Product Advisory

Issue Date: 22-November-2021

Converting Rev B to Rev D tray for 7x7 QFN packages.

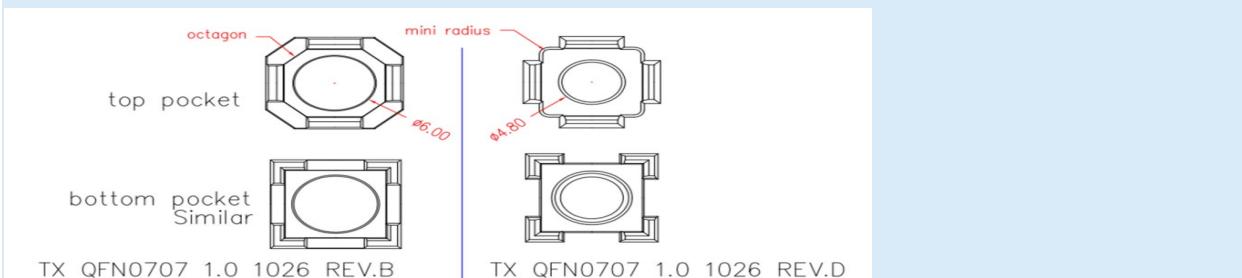
Upref of PEAK tray used in above mentioned part number TX QFN 0707 1.0 1026 from rev B to rev D, dimension shown below.

Just the tray change whereby Rev D tray design have bigger seating plane. Both rev D and rev B trays are not stackable.
